AfterShokz LLC

This is to request a Class II permissive change for FCC ID: SHKASCEHB8. The changes between them as following:

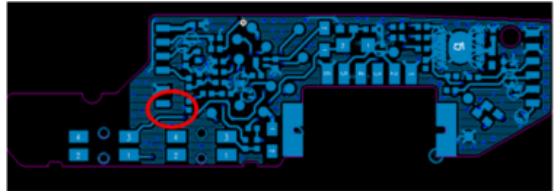
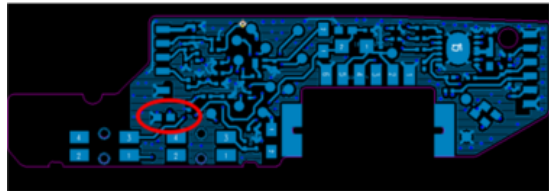
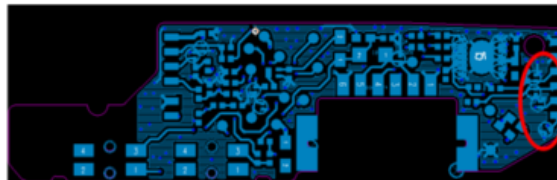
Delete the NTC of the battery, add a new NTC in the product circuit (Negative Temperature Coefficient Resistance). MIC part TVS location changed. Details as below:

<p>Original version NTC at battery</p>	<p>Update version NTC at main PCBA</p> 
	<p>Add NTC</p> 
	<p>Update MIC part TVS location</p>

RF output power and Radiated Spurious Emissions were re-tested based above.
